North South 400 kV Interconnection Development

Discharge of Condition 7 on Material Storage Yard of ABP Order 02.VA0017

Document No.: PE687-F0422-R422-025-002

Additional information has been provided in the report in response to queries from Monaghan County Council following their review of the report.

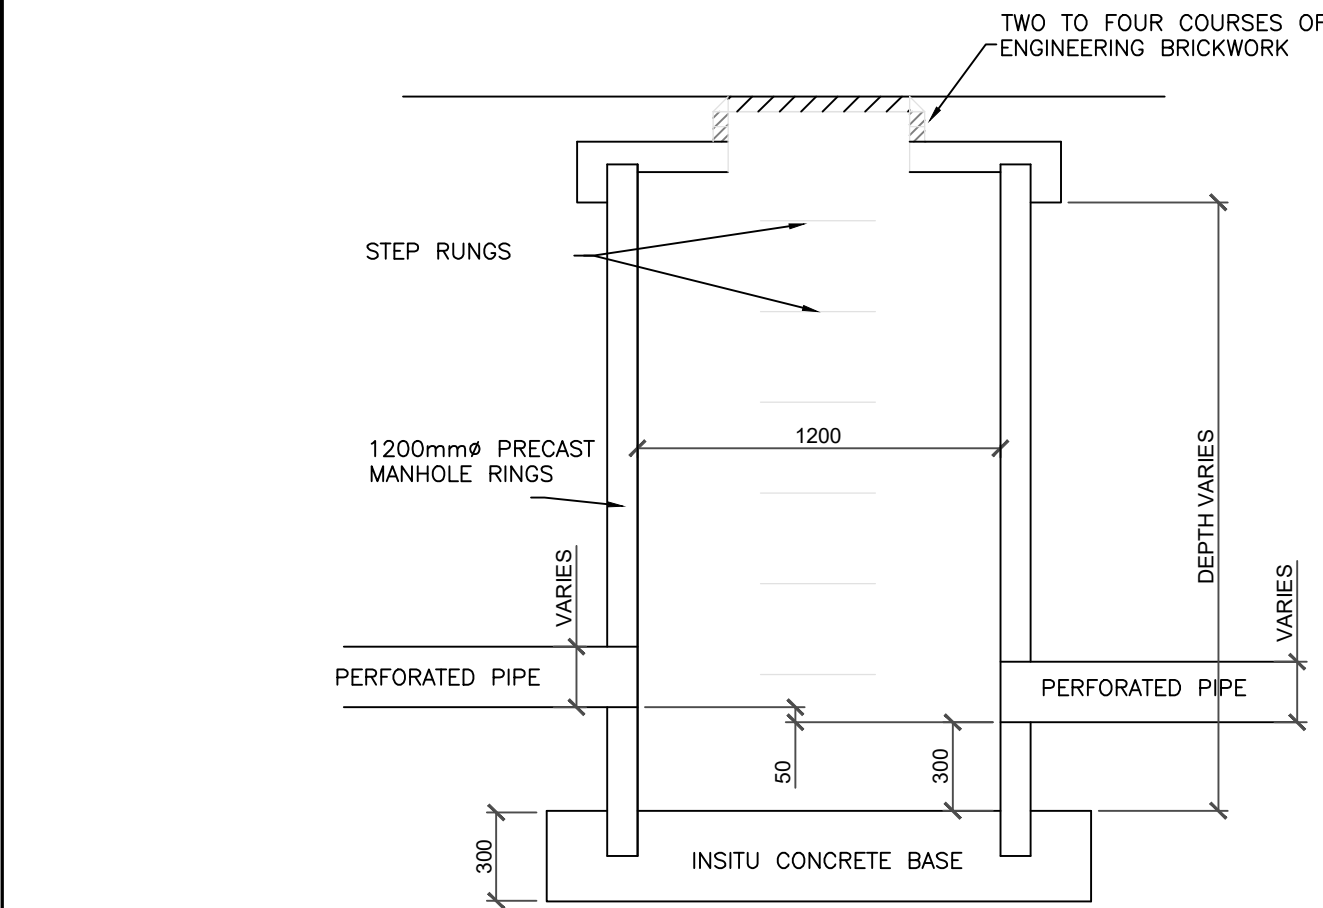
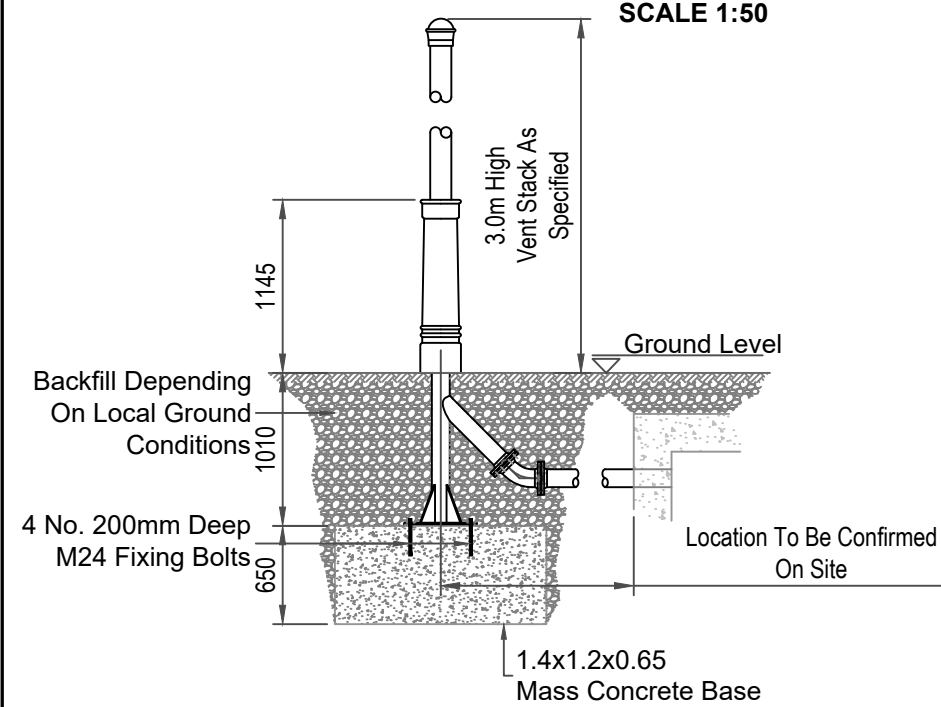
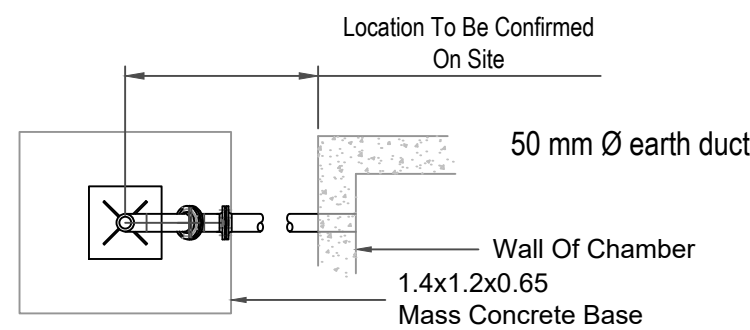
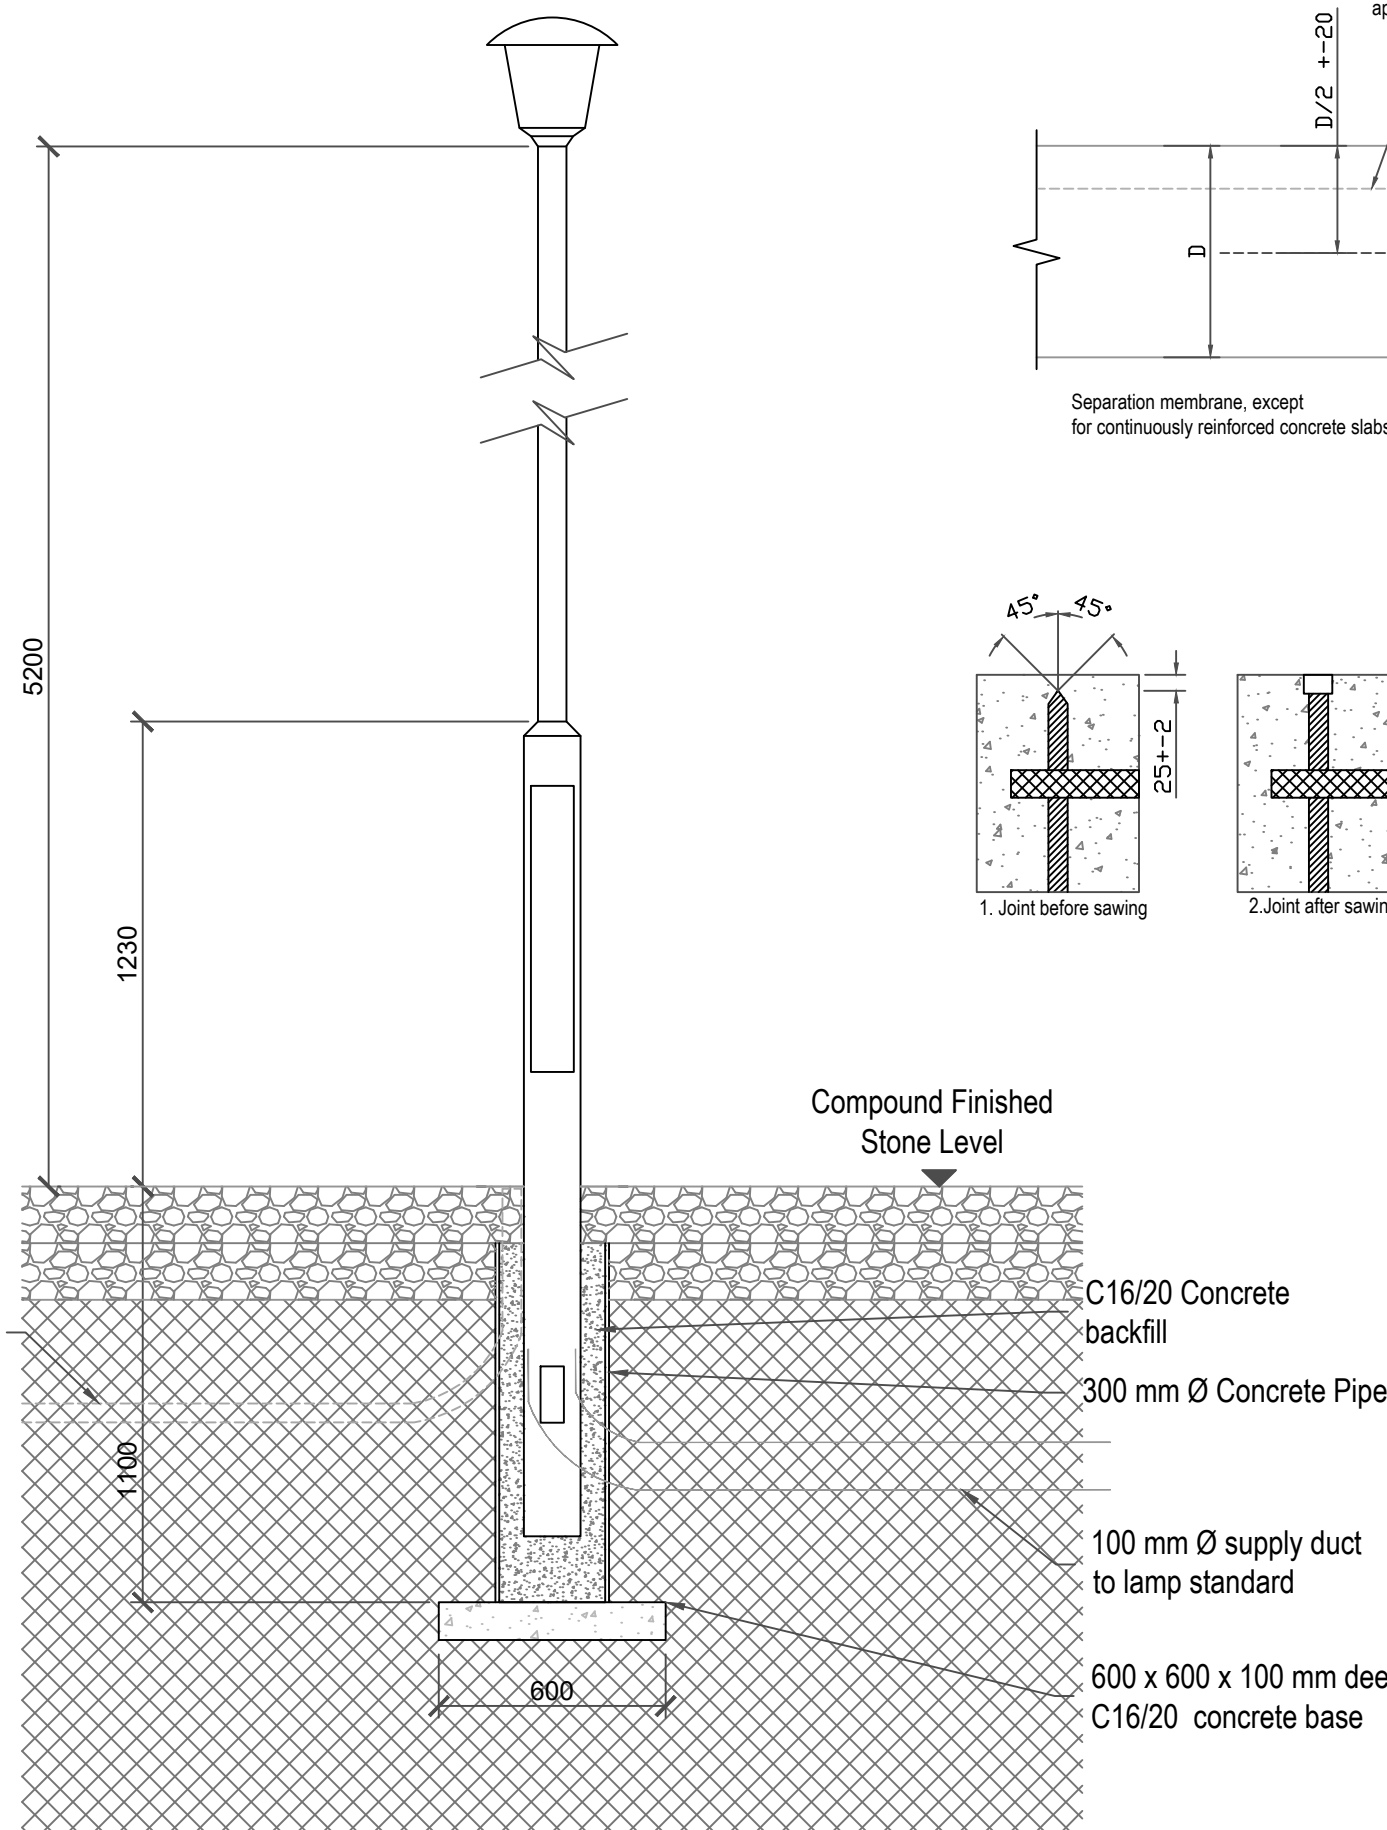
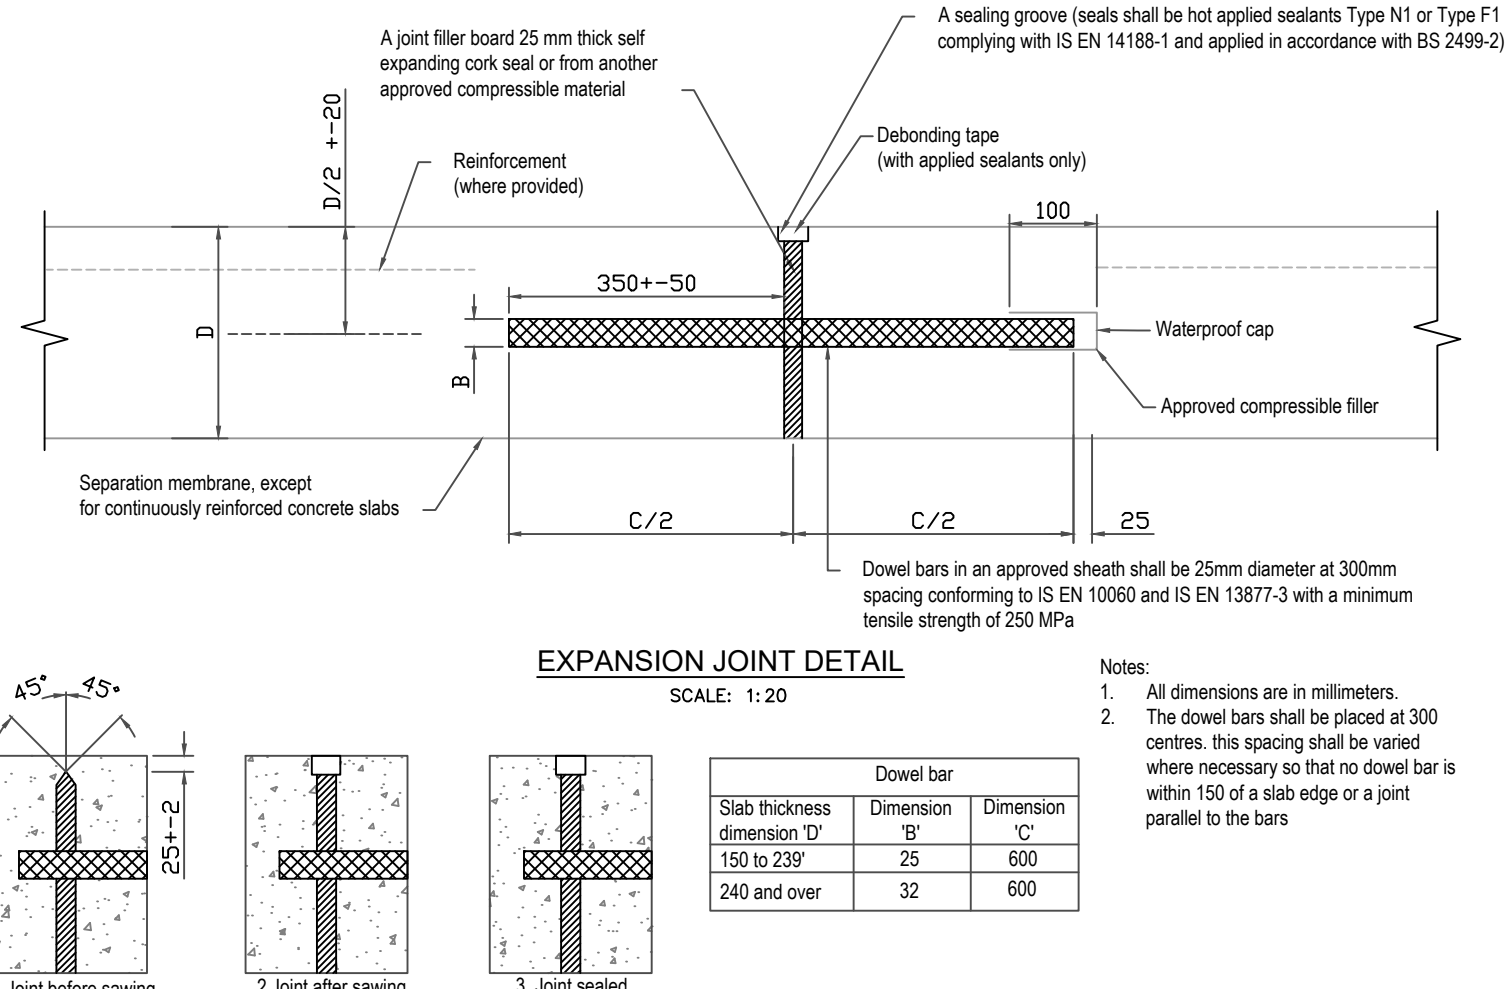
Scaled plans and elevations of the following structures proposed to be placed on the site;

For point f, refer to drawing 24051-MWP-ZZ-ZZ-DR-C-0112 which indicates lighting column heights at all lighting column locations.

Drawing title	North - South 400 kV Interconnector Proposed Temporary Construction Material Storage Yard Proposed Structures Waste Collection and Pole Storage Equipment
Production unit	Transmission and Distribution Delivery

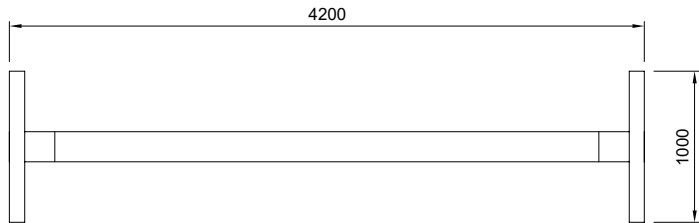
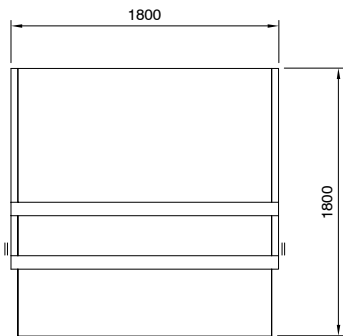
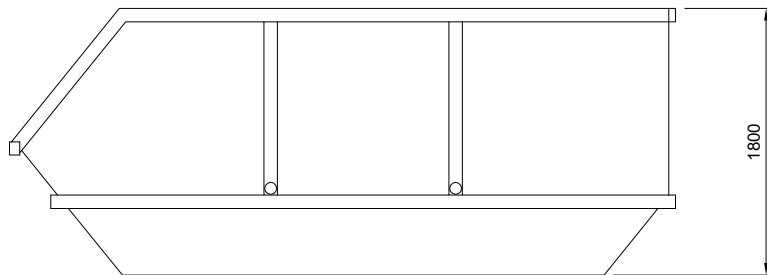
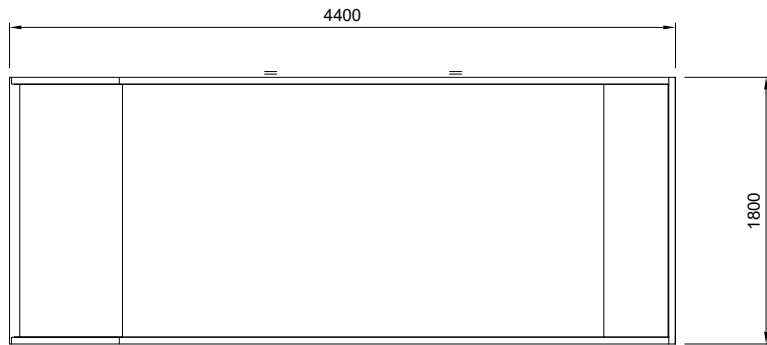
and scaled plans and elevations of all structures proposed to be erected on these areas.

In respect of items 1(a) to (d) of the correspondence dated 25th June 2025, the plans submitted on 28th August 2025 of the prefab staff offices, portable toilets, nut and bolt store, waste collection area do not include all of the elevations. Furthermore, the plans submitted do not correlate with the dimensions of the temporary structures indicated on the site layout plan.

For points a, b, c, d, please refer to drawing PE687-D422-041-001.

For point a, please refer to Pole Stanchion Plan and Elevation views on drawing PE687-D422-041-001.

For waste collection area, please refer to drawing PE687-D422-041-001.

Appendix 3 – Material Storage Yard Demolition, Reinstatement and Reinstatement Details Drawings

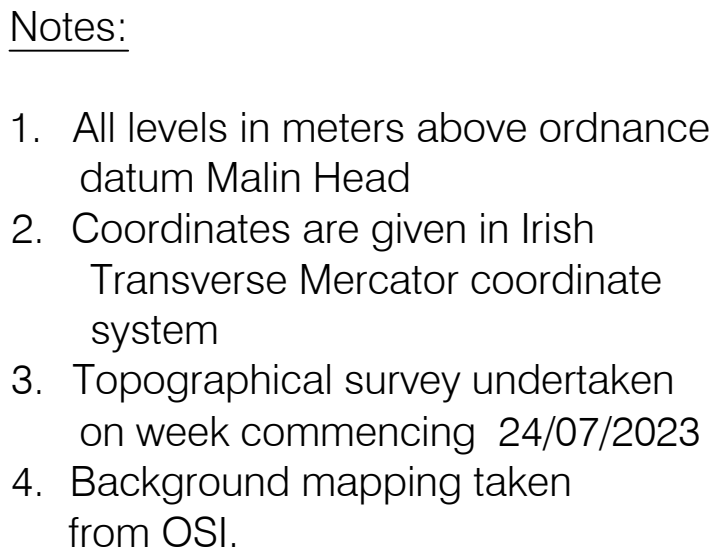
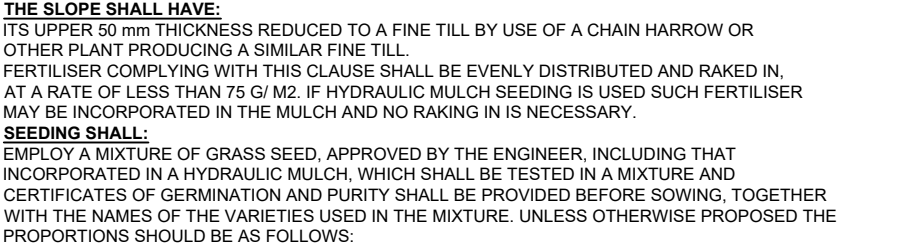
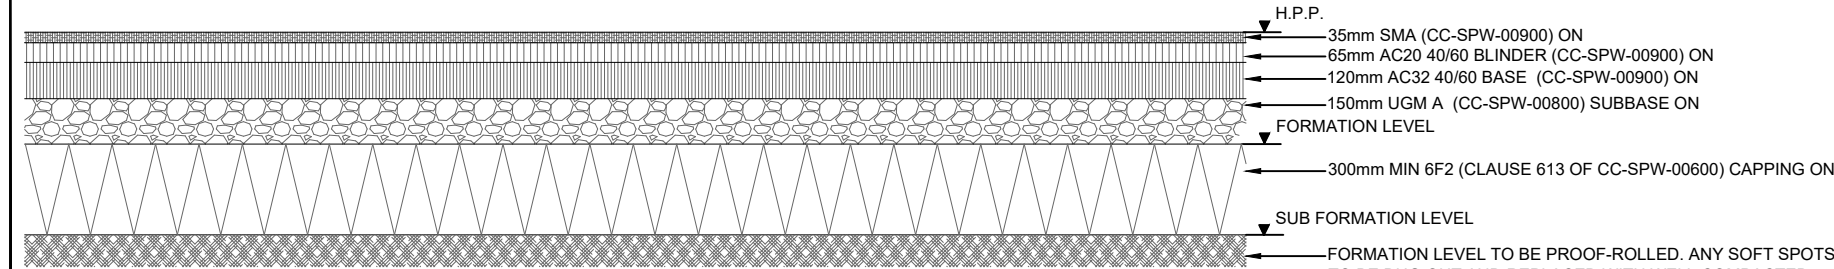
Clarification of the proposal to reinstate the roadside wall on the restoration site layout plan (drawing PE6897-D422-039-002) and details of same.

Note on drawing PE6897-D422-039-002 updated to indicate roadside bank to be reinstated as no wall could be identified during follow-up site visit.

PROJECT: North South Interconnector Storage Yard Co. Monaghan		CLIENT: ESB Major Projects
DRAWING: Landscape Mitigation Plan - Sheet 1		SCALE: 1:500
DATE: Jul 2025	DWN BY: YA	CKD BY: RB
SHEET SIZE: A1 (landscape)		DWG No. LD_NSINTER 3.1

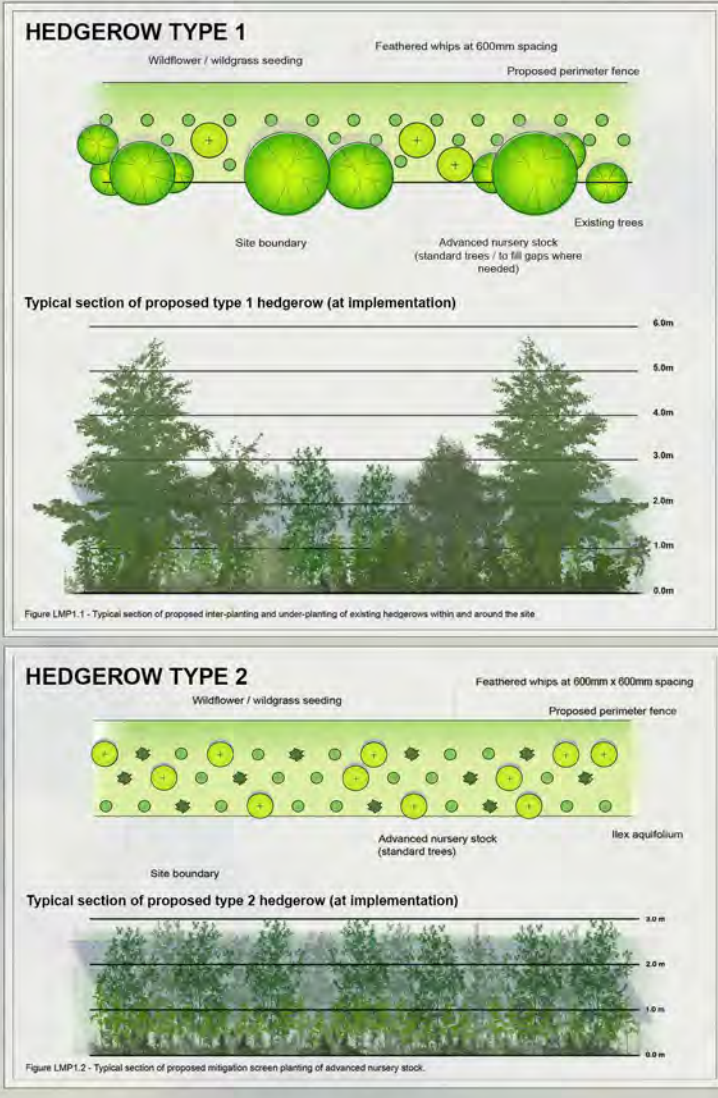
A site layout indicating details of landscaping along the northwestern, southwestern and southeastern boundaries of the site to facilitate the visual screening of the site and the structures proposed to be placed on it, particularly where the hedgerow is required to be removed to facilitate the provision of the required visibility splays. The details of landscaping should include types, heights, location and numbers of trees and hedgerows to be planted, and the timescale to do so as the first planting season following commencement of the works.

Please refer to drawing in Appendix 4.
